Subject: Response to Nuclear Regulatory Commission Request of October 13, 1999, for Additional Information on Ground Water Compliance Action Plan and Alternate Concentration Limit Application for the Canonsburg, Pennsylvania, Title I Uranium Mill Tailings Site

## **Canonsburg GCAP/ACL NRC Request for Additional Information (RAI)**

**Revision of the Canonsburg ACL Application (Document Number U00358AA – September 1998) – this will replace Section 3.0 starting on page 43. This revision addresses Comment 2 in the NRC RAI of 13 October 1999. (Note – original color Figures 3-1 through 3-4 will be placed in the final version of the document).**

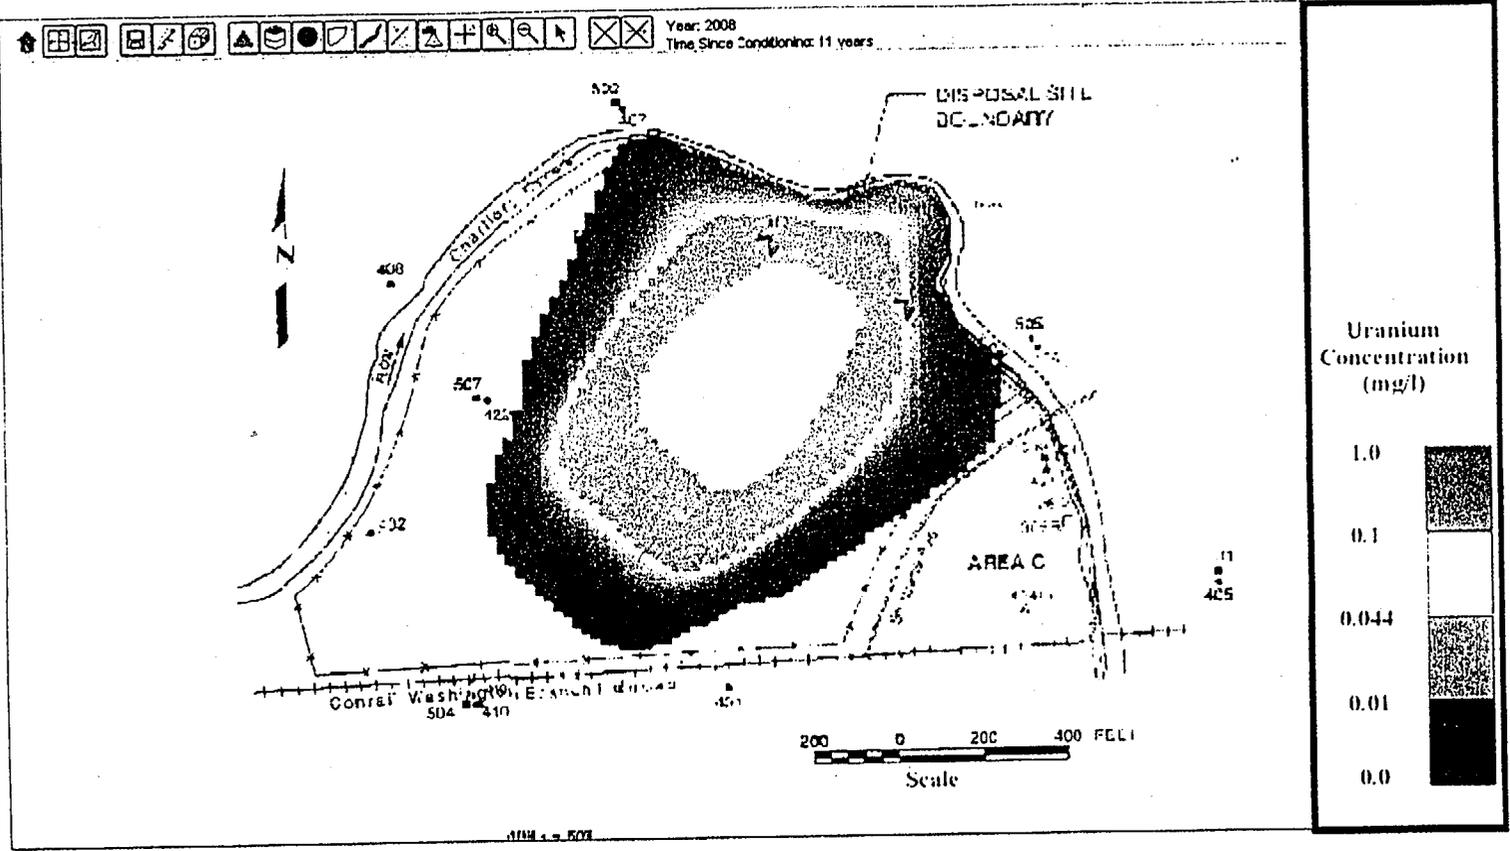
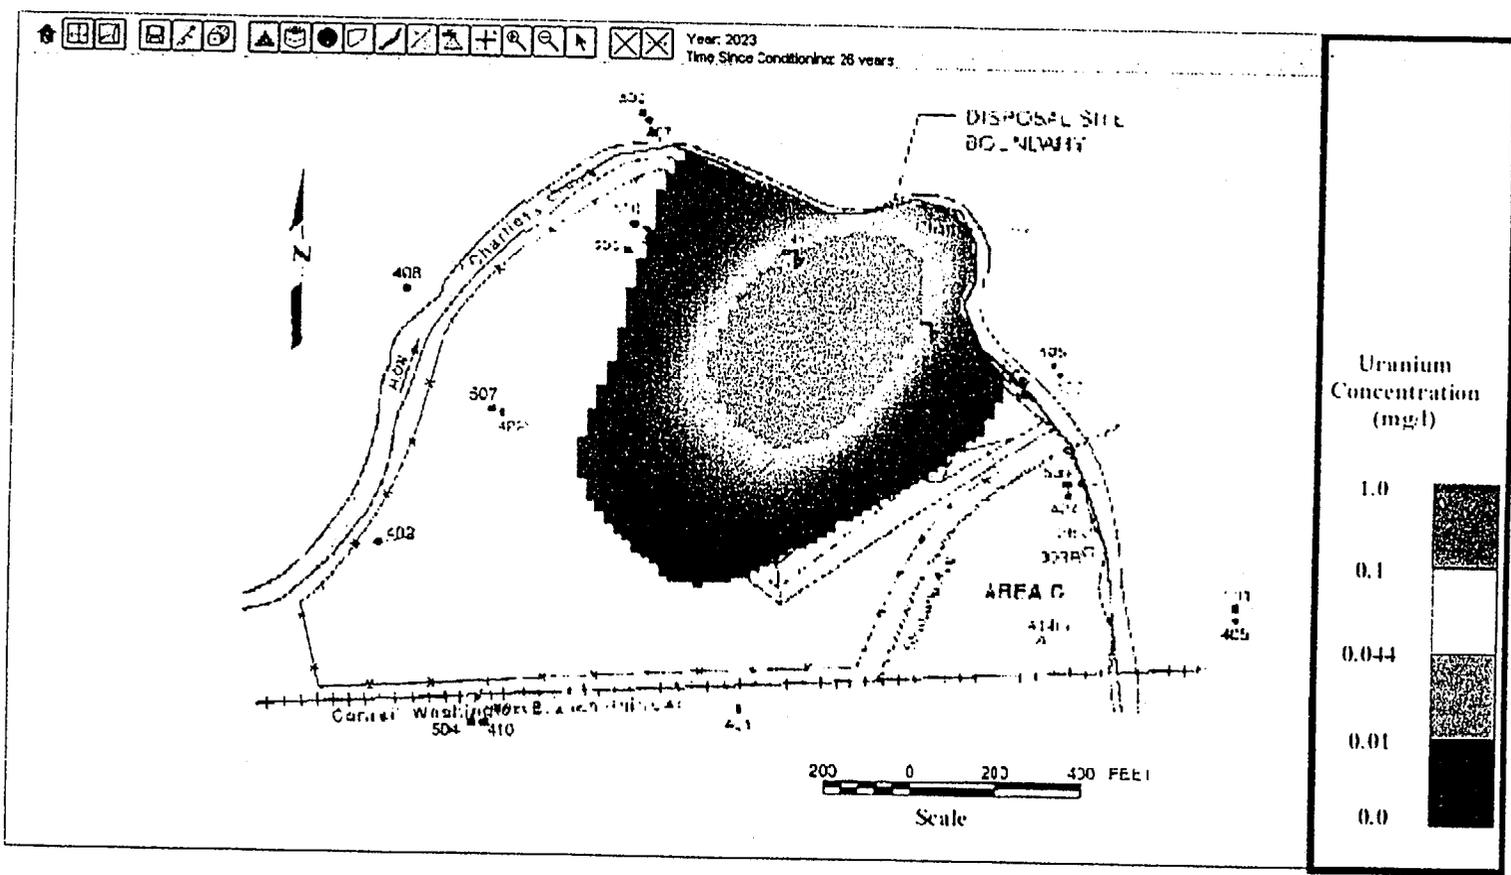
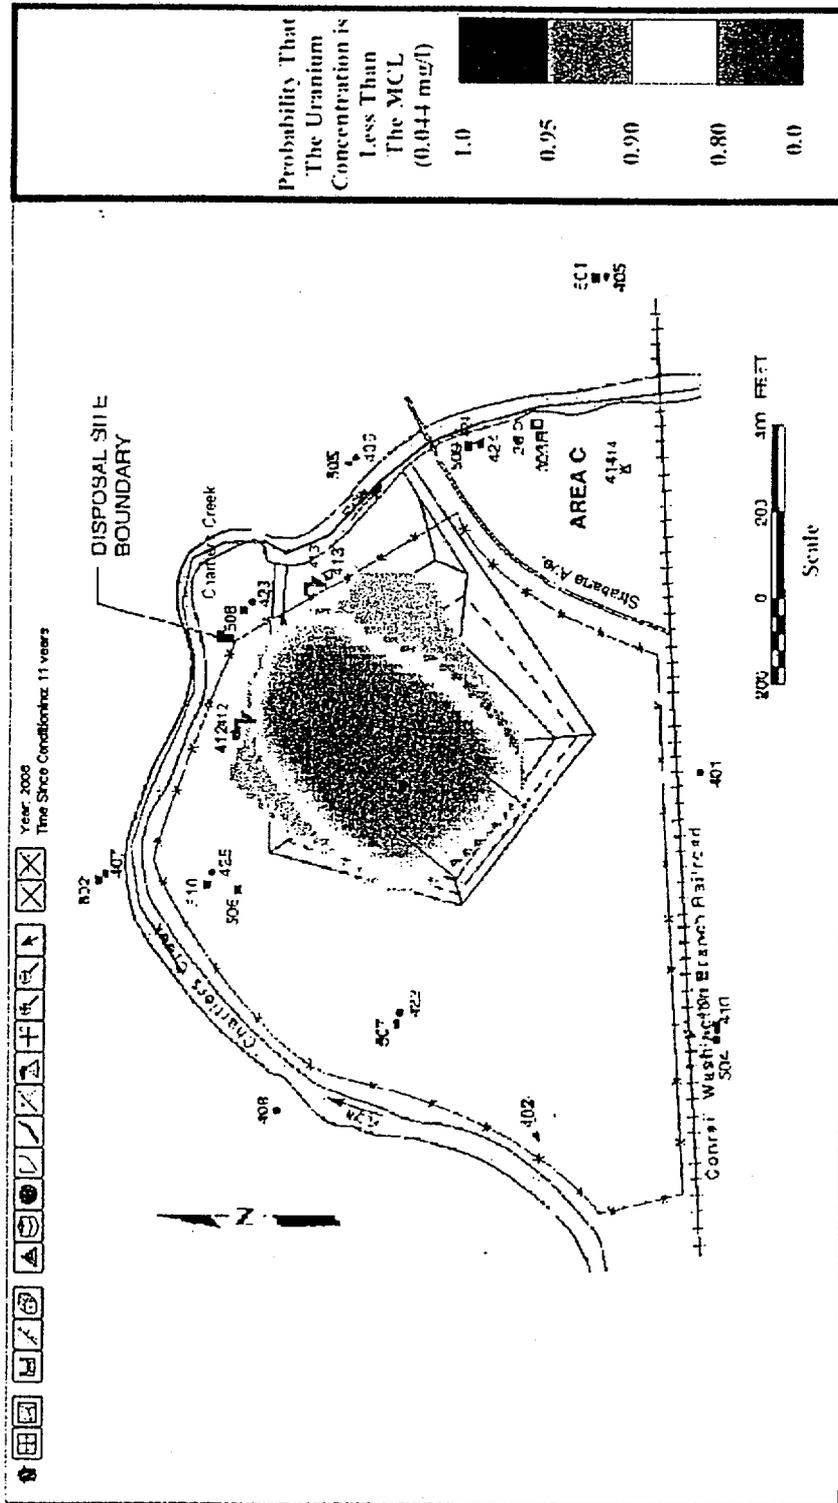
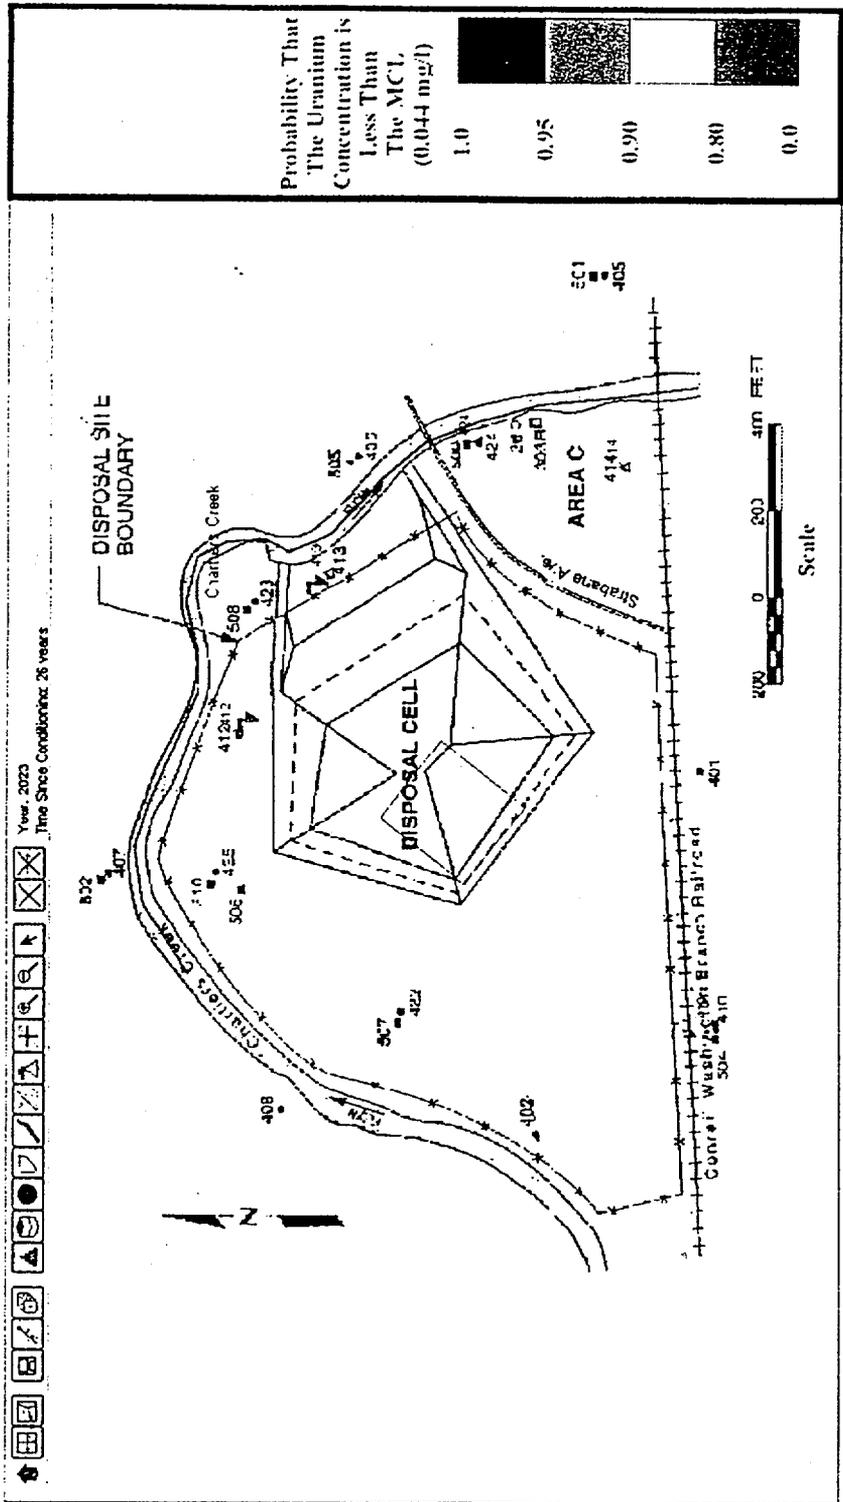
- *Comment 2: The remedial alternatives should be expanded.*

Section 3.0 of the ACL Application will be revised to follow more closely the 1996 NRC ACL guidance and the framework discussed in the RAI. The revision of Section 3.0 is attached.

The modeling results suggest that a pump-and-treat scenario will do little to enhance the cleanup of the aquifer in a timely and cost-efficient manner. Figures 3-1 and 3-2 show the average concentration distributions of uranium at the site through time for the pumping scenario discussed above. Figures 3-3 and 3-4 show the probability distributions for the likelihood of concentrations being less than the MCL. Additional time frames are shown in Appendix C for both average concentration distributions and probability distributions in order to visualize the transient effects of a pump-and-treat scenario. From these simulation results it is likely that the pump-and-treat scenario will help clean up the site within 15 to 20 years.
